San Francisco Bay Conservation and Development Commission

SUBJECT: India Basin Shoreline Park Project, San Francisco, CA (BCDC Pre-Application)
(For Board consideration on December 6, 2023)

India Basin Shoreline Park Project (BCDC Pre- Application)

Figure 2. Enlargement of Detail 4, Section B-B' from the preliminary design of the proposed South Marine Way Wall, India Basin Shoreline Park (Permit Set Geotech Plans by AGS dated 10/20/2023)

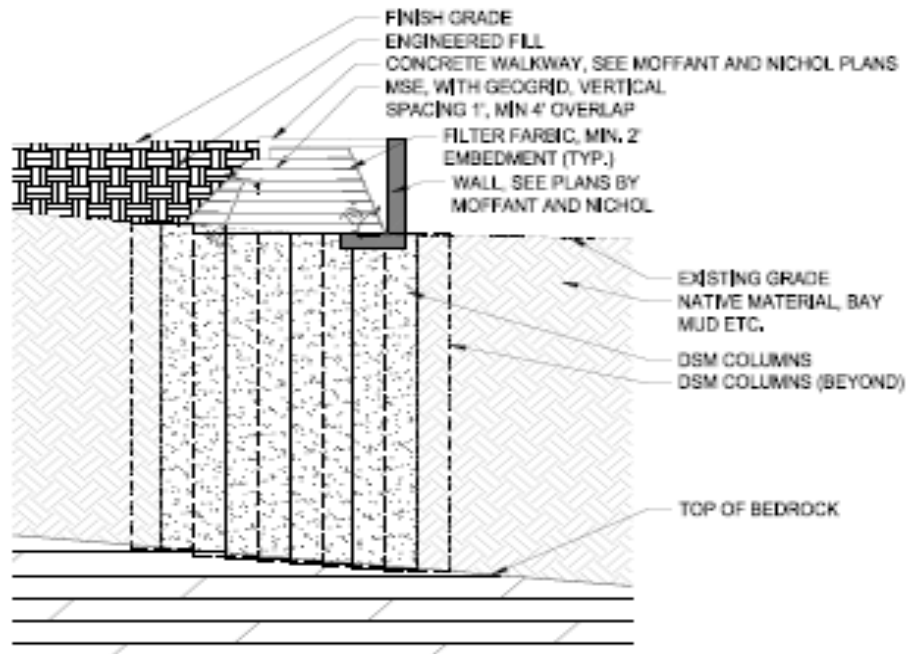
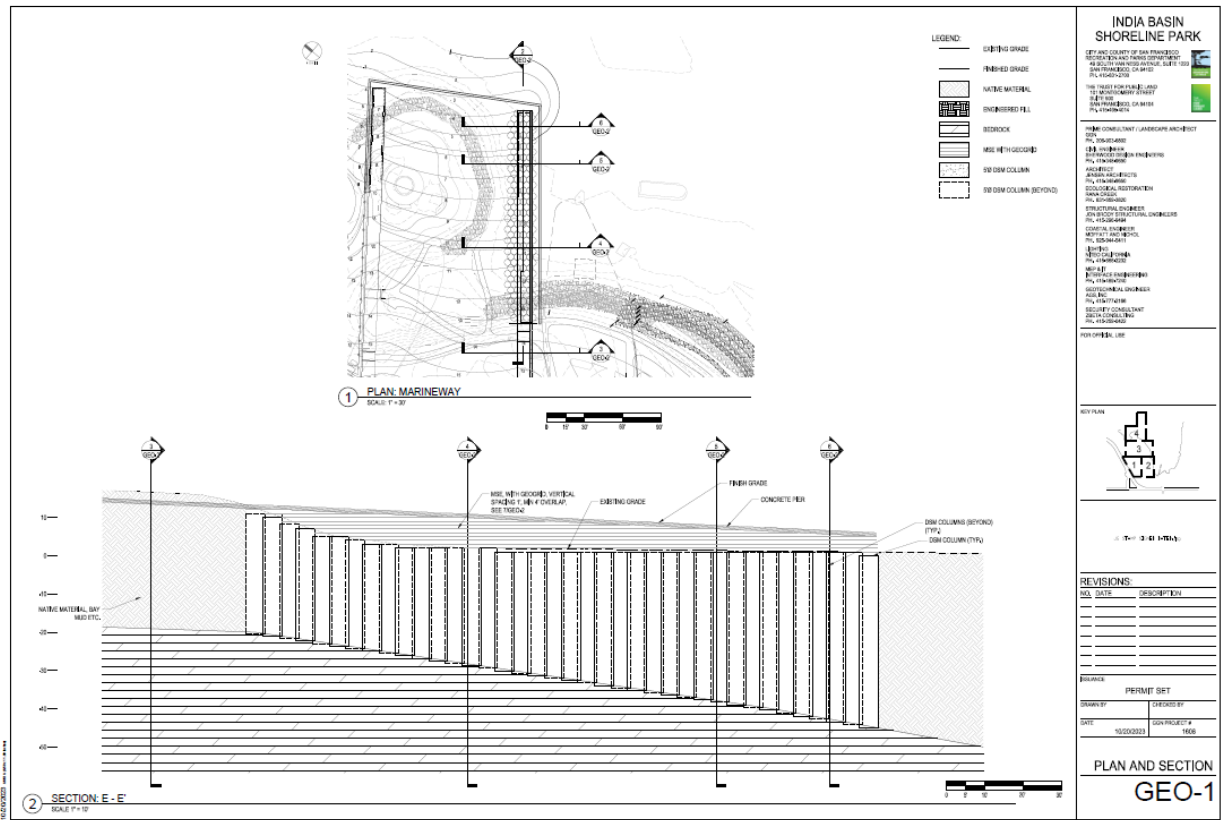
1. Are the scenarios and design criteria in the stability analyses for the piers and the South Marine Way appropriate for the site hazards, site conditions and site criticality?
2. Are potential hydrodynamic impacts from the South Marine Way wall a concern?
3. Are future coastal flooding concerns from sea level rise addressed adequately in the park design?
4. Is there any data monitoring you recommend BCDC require of the applicant to enhance the future safety of the project in light of its projected 40-year estimated design life?
5. Are there any other design and physical concerns that have not been addressed?
